### Staff Report & Recommendation

### Historic Preservation Board

SUBJECT: HPB20-0390, **4441 Collins Avenue.**

An application has been filed requesting a Certificate of Appropriateness for modifications to the existing Tresor Tower including the construction of a new ground level vertical circulation structure in order to facilitate the construction of a new pedestrian bridge over the 44th Street right-of-way connecting the subject property to 4360 Collins Avenue, including variances to reduce the required street side and sum of the side setbacks.

*Proposed connection plan: 4<sup>th</sup> level Tresor Tower parking garage to 3<sup>rd</sup> level ballroom structure*

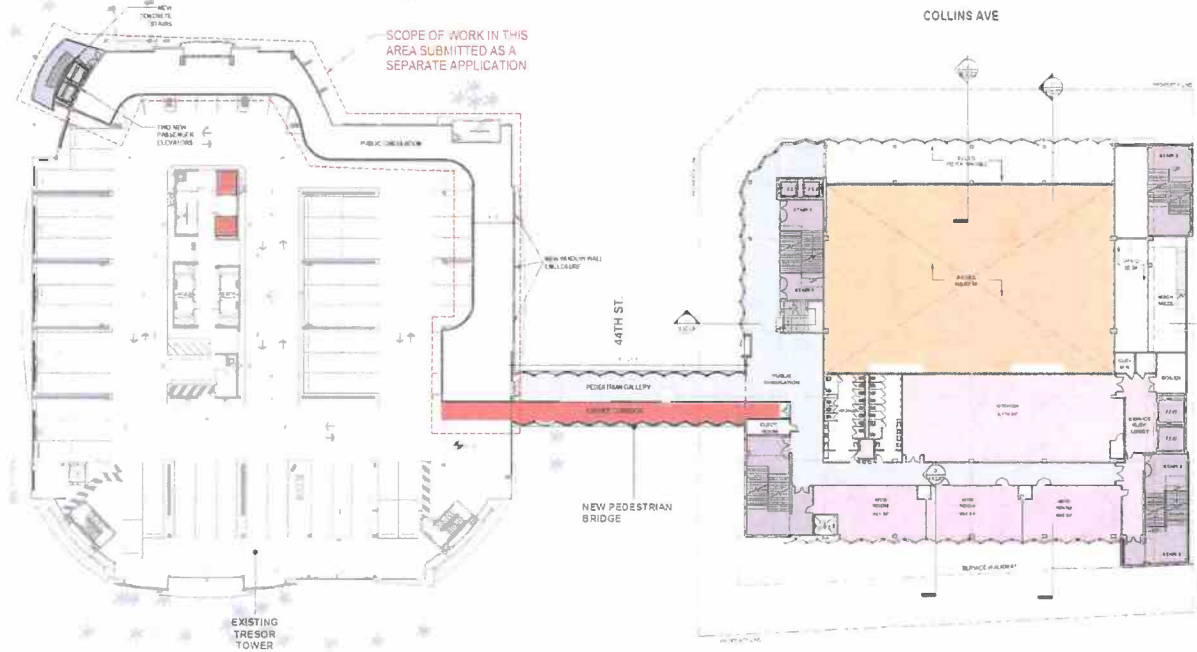
The applicant is currently proposing to construct a stair and elevator addition at the northeast corner of the Tresor Tower. This addition will allow for a direct connection from the hotel to the new building via a new enclosed walkway at the fourth level of the Tresor Tower parking garage and a proposed pedestrian walkway over 44<sup>th</sup> street. In connection with the enclosure of a portion of the parking garage for a new walkway, certain existing louver openings along the perimeter of the parking level will be converted to windows.

The application is fairly straightforward, and staff has no design concerns. Further, the proposed modifications will not have any adverse impact on the historic structures on site or the surrounding historic district. As such, staff recommends approval as noted below.
